15th April 2024

Abi Mark
Senior Environmental Planner, WBOPDC
1484 Cameron Road
Greerton, Tauranga 3112
Via email: abi.mark@westernbay.govt.nz

Response to Submissions, Further Mitigation Plan Change 95 – Pencarrow Estate Pongakawa

- Riparian Planting to Stream Bank
- Existing Trees
- Proposed Large Trees
- Proposed Medium Trees

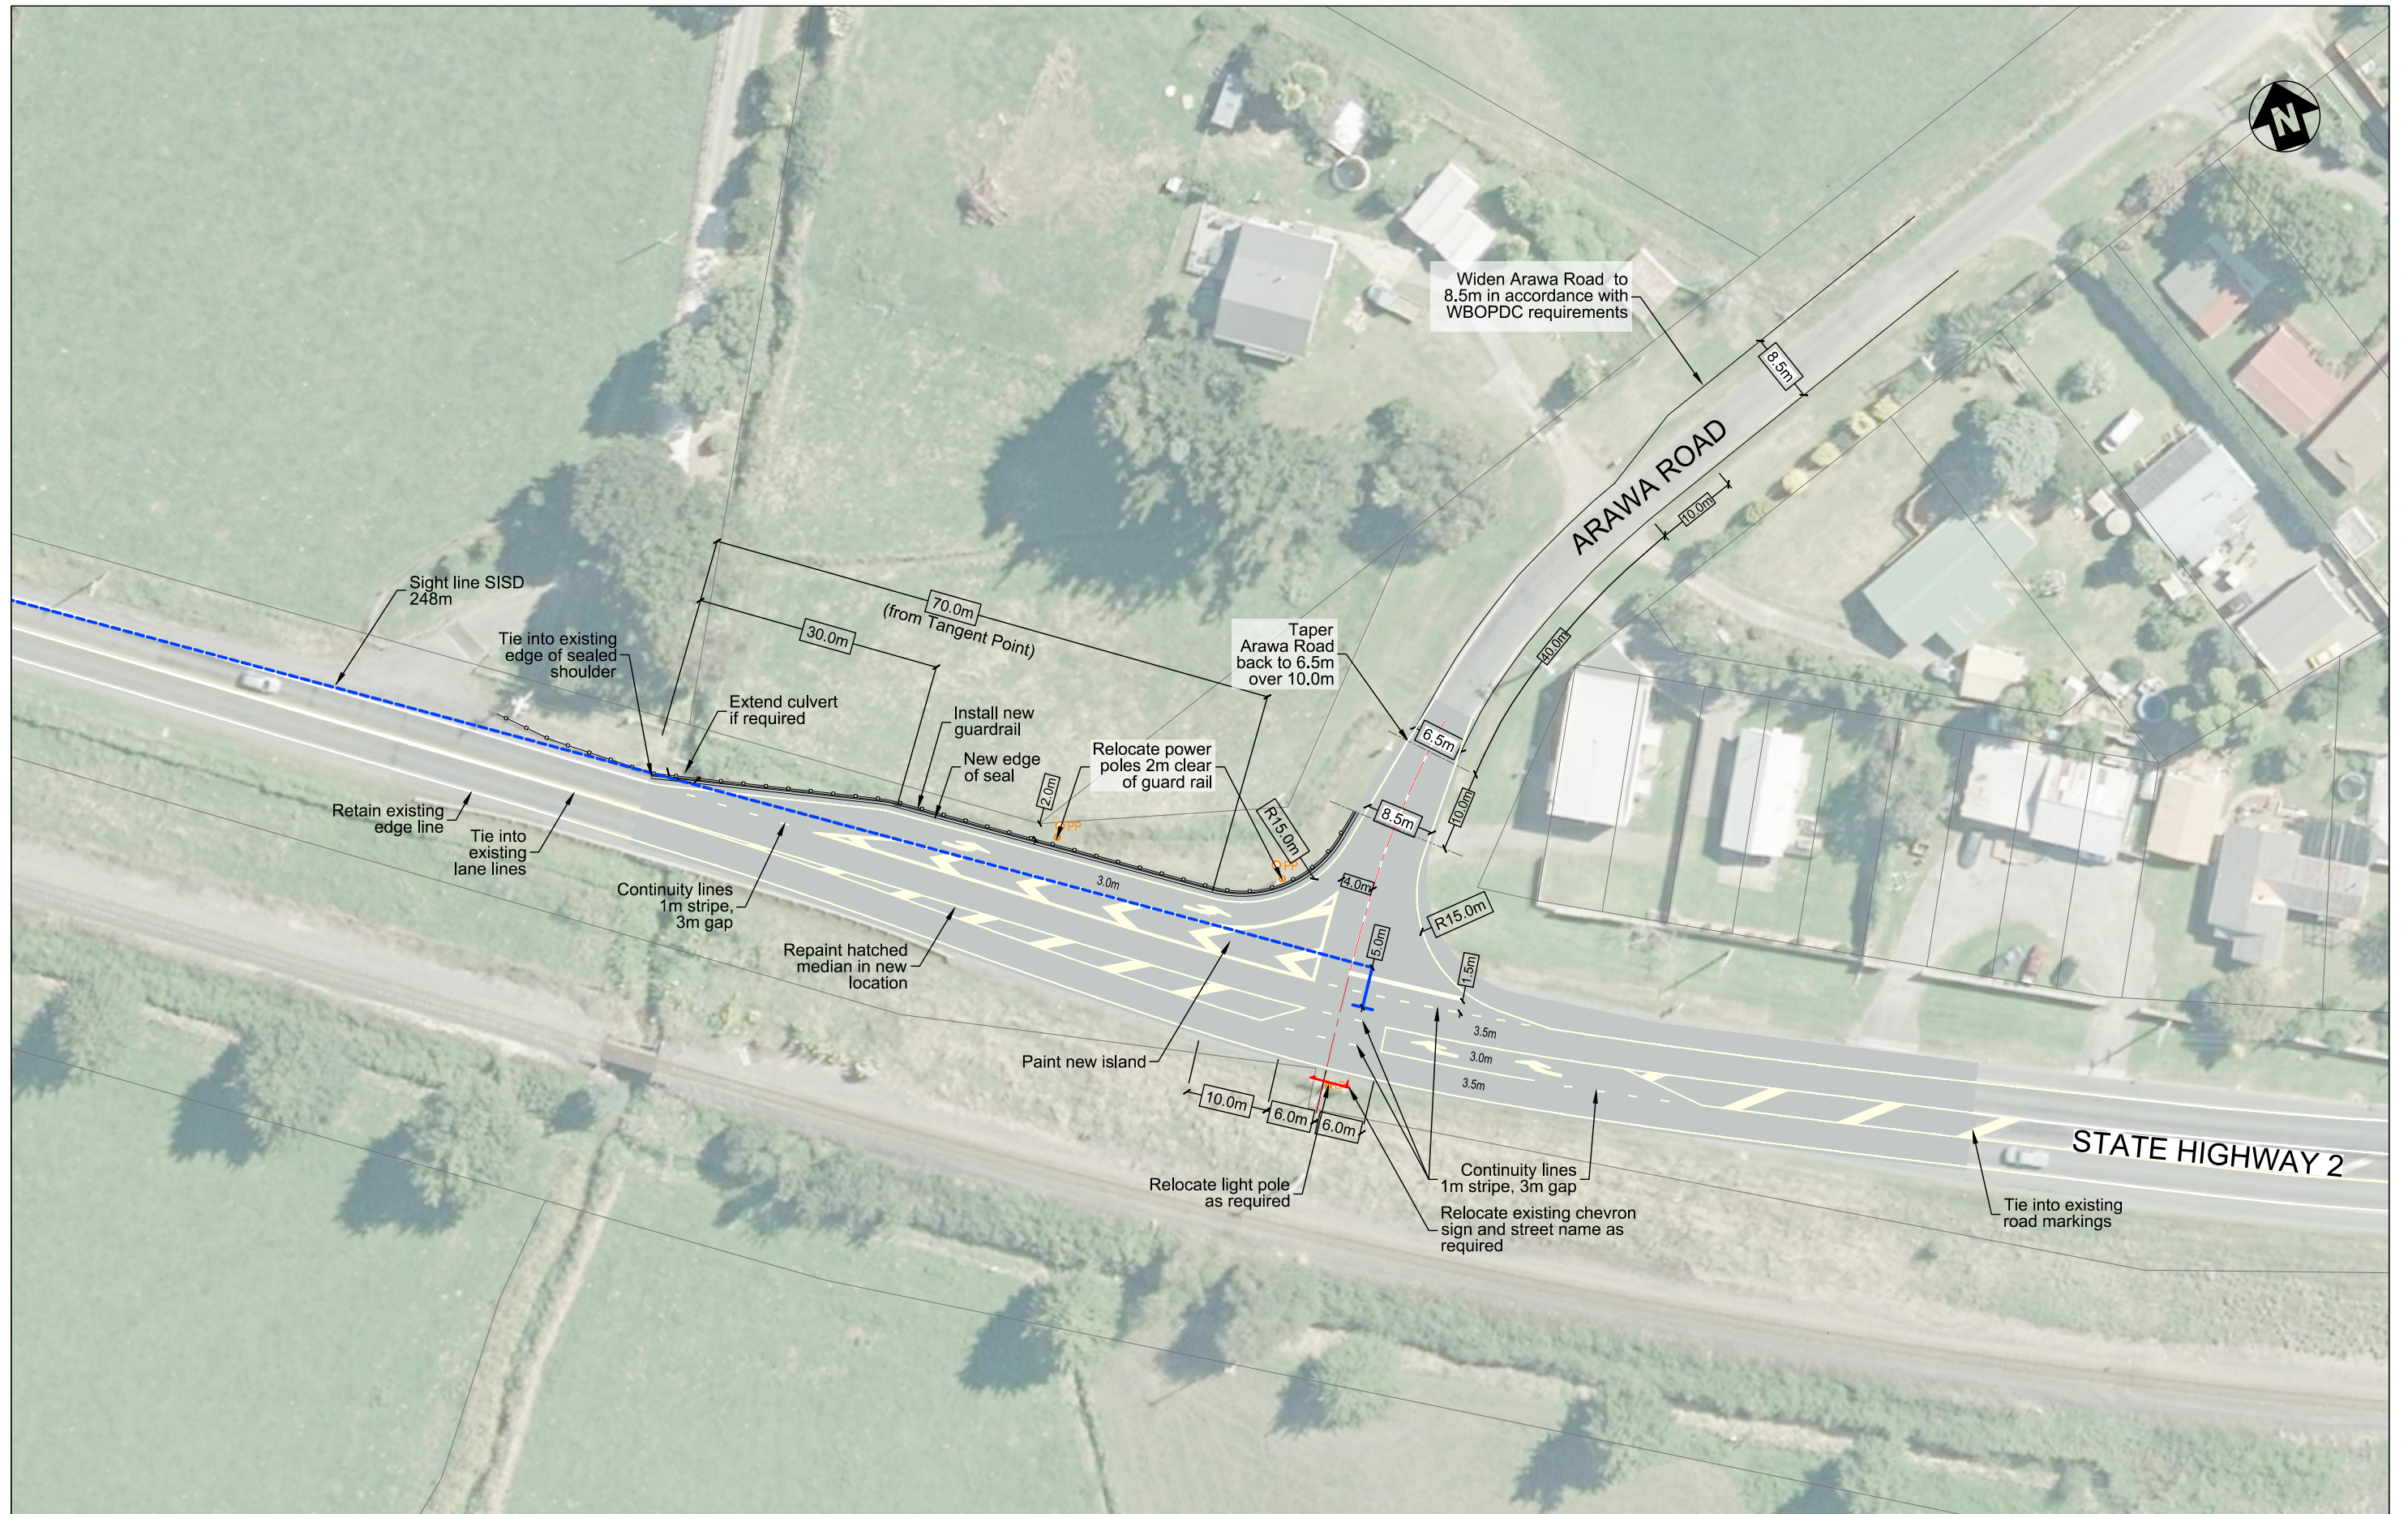
Numerous submissions discuss the general loss of rural character and amenity that accompanies urbanisation. This change is acknowledged, particularly in respect of Rural-zone properties on Arawa Road abutting the plan change site to the south-east. Adverse effects attached to this change have been sought to be reduced, by way of restricting the height and siting of future built form adjacent to eastern boundary of the site. Future building height adjacent to the eastern boundary is restricted to one storey.

Initially a set-back of 5m was applied to the eastern boundary of the plan change site, in combination with the height restriction. This being derived from considering the range of setback distances/boundary-constructed buildings along the rear boundary of Arawa Road properties. Noting concerns about outlook and spatial separation to future built form that have been raised in submissions, this setback has been increased to 8m. Trees have also been specified in this setback for greater natural elements within outlook towards the plan change area. This is reflected in revised proposed wording of rules to apply within Chapter 13 of the District Plan, see **Appendix B**, and revised structure plan drawings at **Appendix C**.

No	DESCRIPTION	DATE	CHK
A	ARAWA ROAD WIDTH REVISED	15/03/24	BH

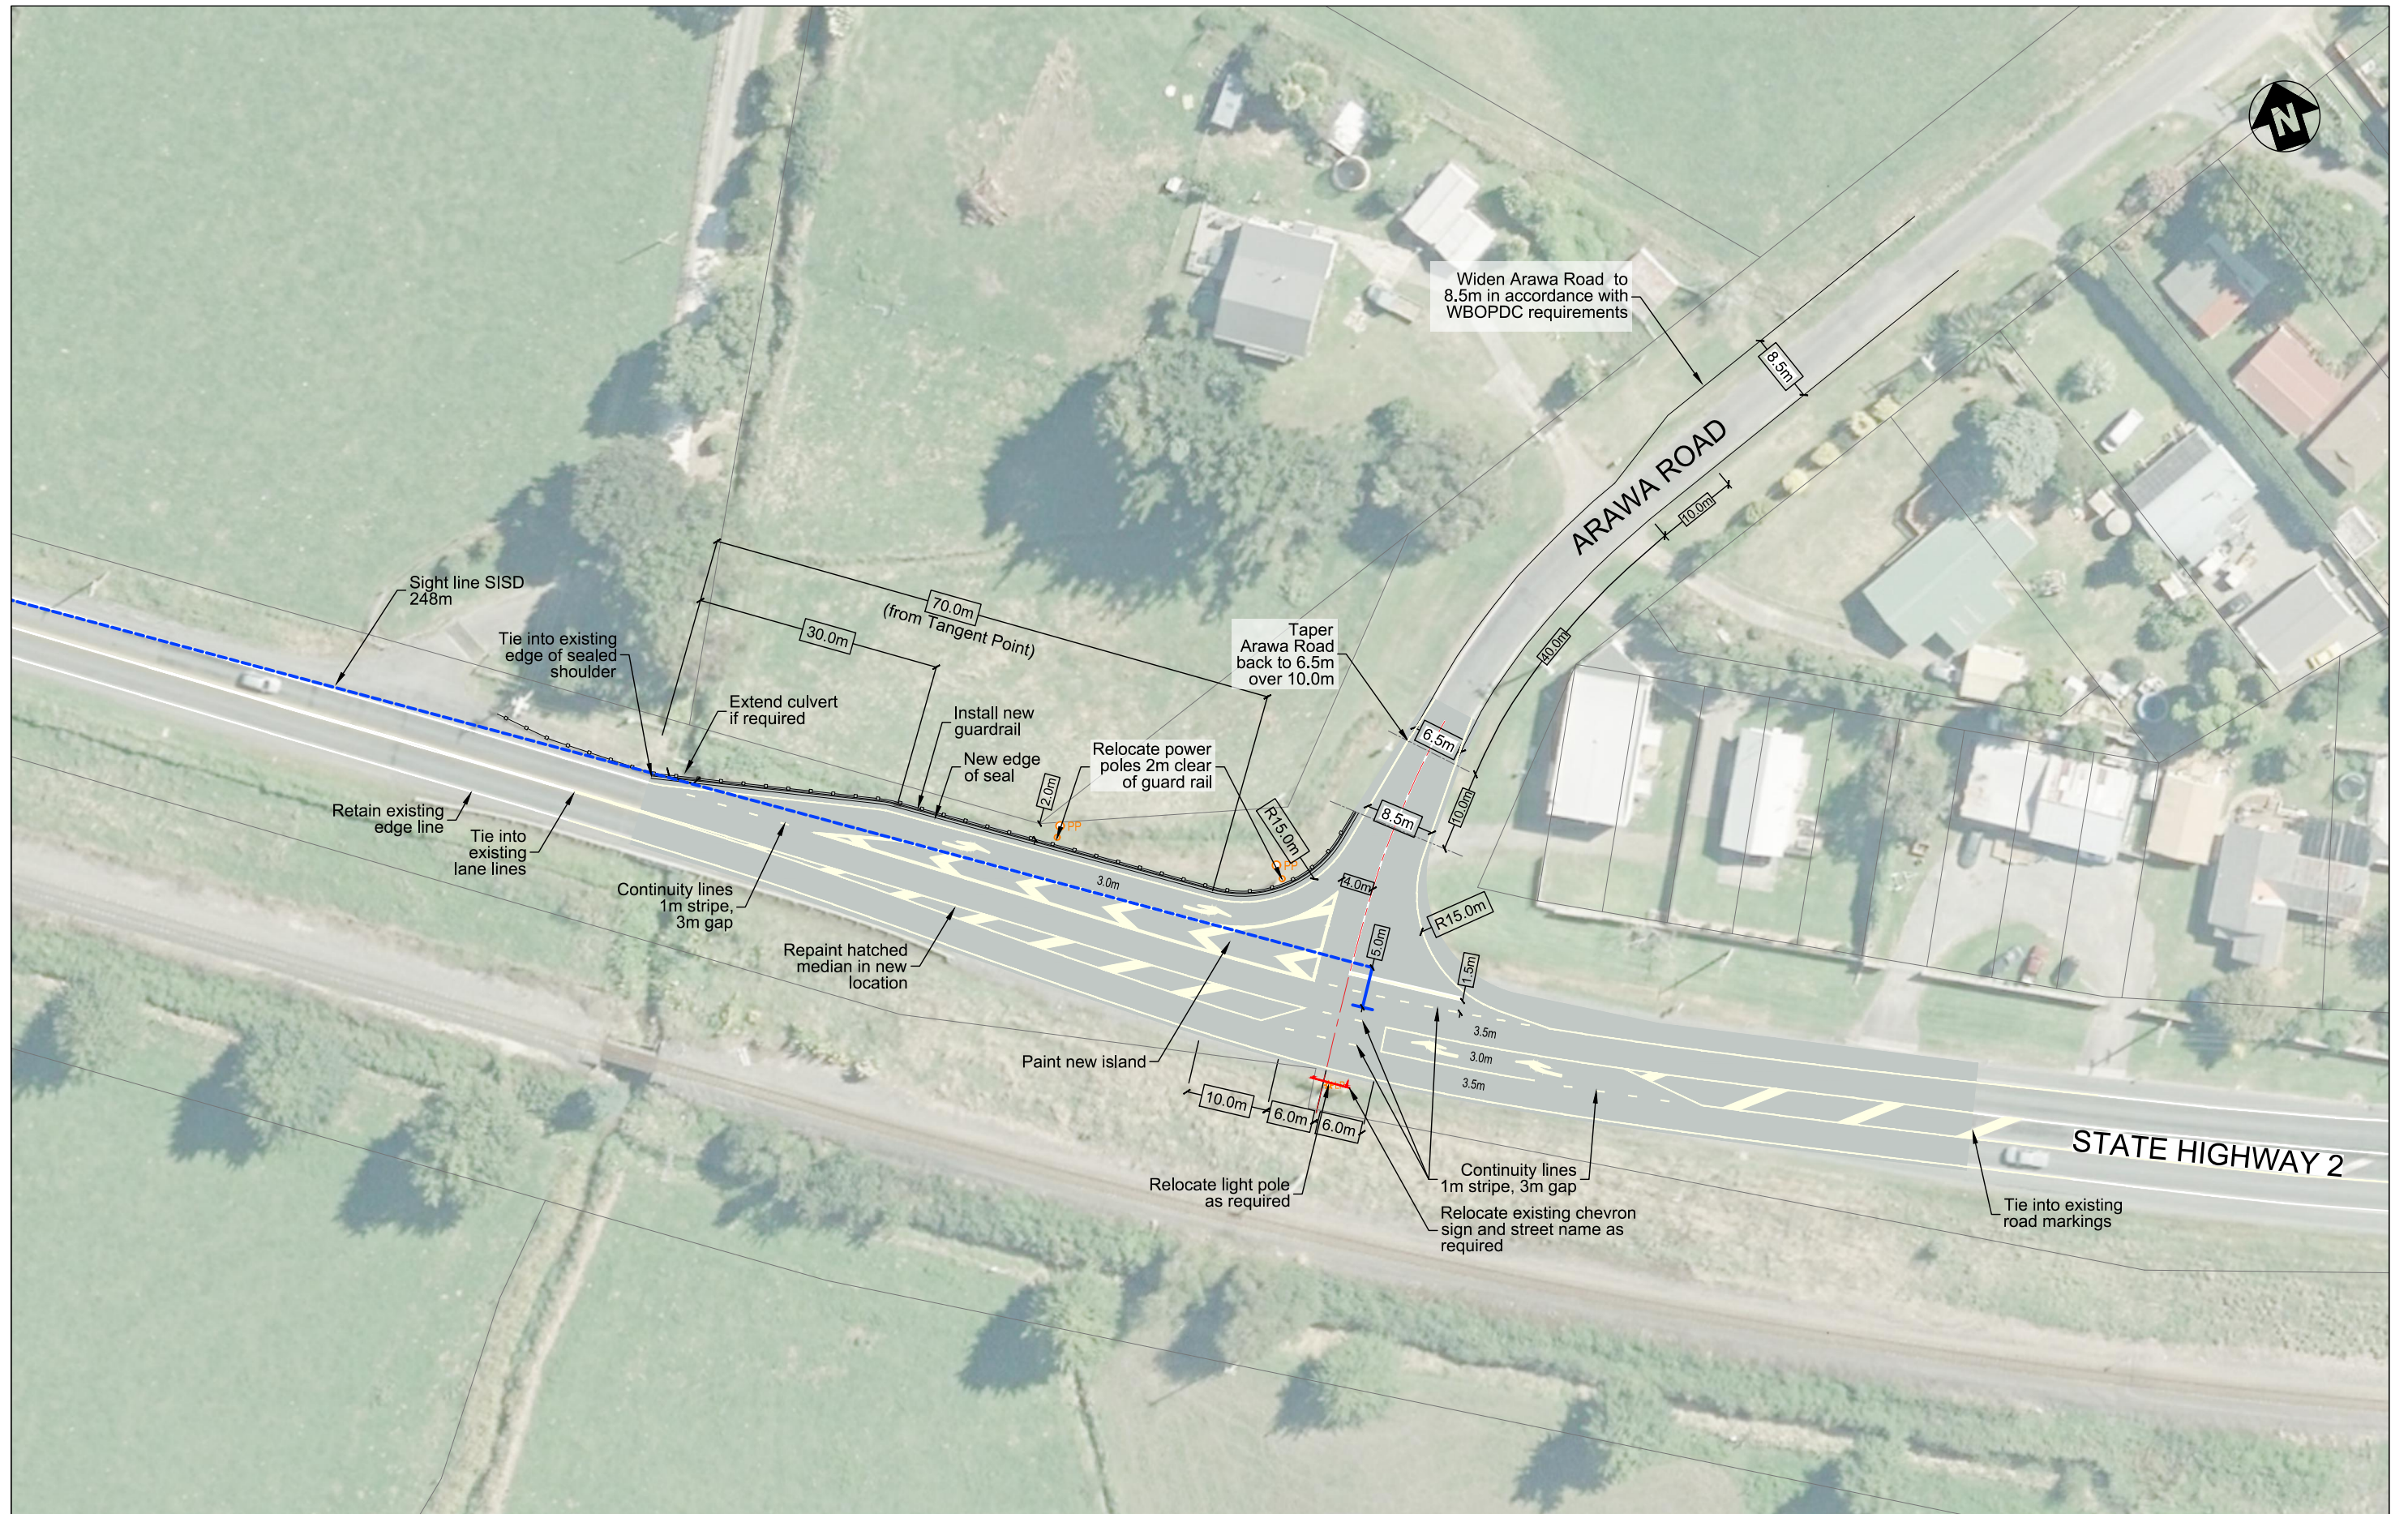
Numerous submissions raise concerns with increases in traffic, both as a function of residential amenity and change in residential character owing to larger volumes, and safety risks particularly at the SH2 / Arawa Road intersection. These are responded to as follows:

- The design of Arawa Road has been amended to balance recommendations of the safety audit, and preferences of WBOPDC and the Arawa Road community, by maximising the width of Arawa Road to 8.5m outside of areas subject to recommendations within the safety audit. This is to the satisfaction of WBOPDC and Waka Kotahi. See meeting minutes and amended plan at **Appendix D**.
